## Corrigendum to RFP for DC Renovation and Shifting

<b>Addendum to RFP for DC Renovation and Shifting</b>	
86,Appendix D , o , Network Distribution System :	The bidder will provide following:  Network cables (CAT 6) must be routed beneath the raised floor through cable raceways. Inter rack cabling must be done using fibre cables. All network and power cabling inside the data centre area (server room, control room, electric room etc.) will be carried out by the bidder.  Network devices viz., switches , patch panels, fibre cables, fibre panels and routers will be provided by the Bank.
87 , Appendix E, g.	Portable fire extinguishers will be provided by the Bank. Bidder has to provision for placing the devices appropriately.

**Appendix-B  
Proposed DC area with dimension**

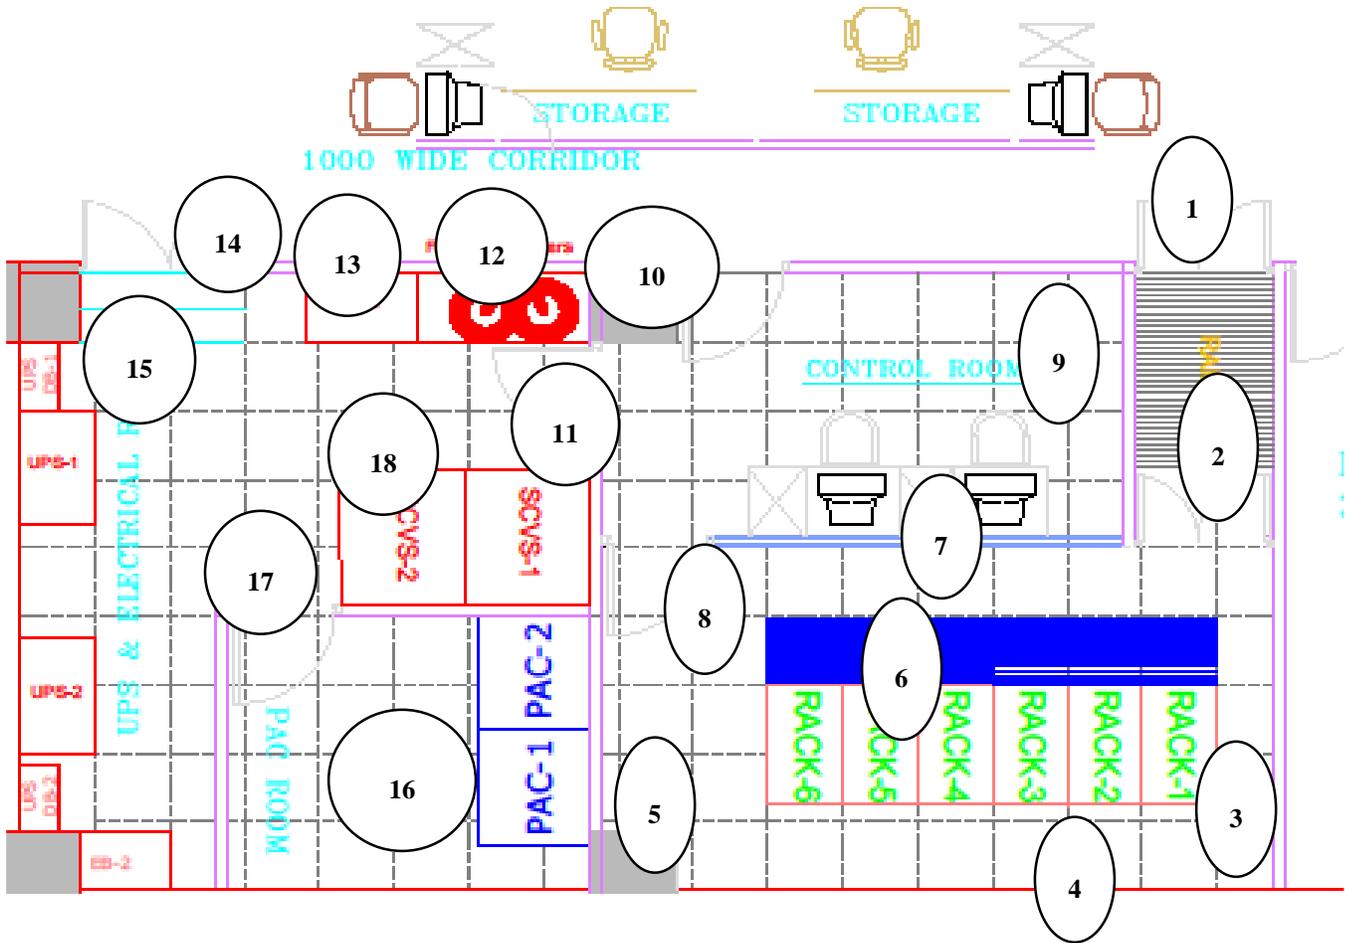
Sl No	Description	Area in mm/Sqmtr
1.	Total area	10150x5500 (LxB) = 54.41 Sqmtr (Approx.)
2.	DC area	19.80 Sqmtr
3.	Electrical room	17.30 Sqmtr
4.	PAC room	7.7 Sqmtr
5.	Control Room	9.61 Sqmtr
6.	Emergency door size	2.7 Sqmtr

7.	Entry door size	2.0 Sqmtr
8.	True floor to true ceiling	3530 mm
9.	True floor to false floor	450 mm
10.	True ceiling to false ceiling	600 mm
11.	False floor to false ceiling	2830 mm
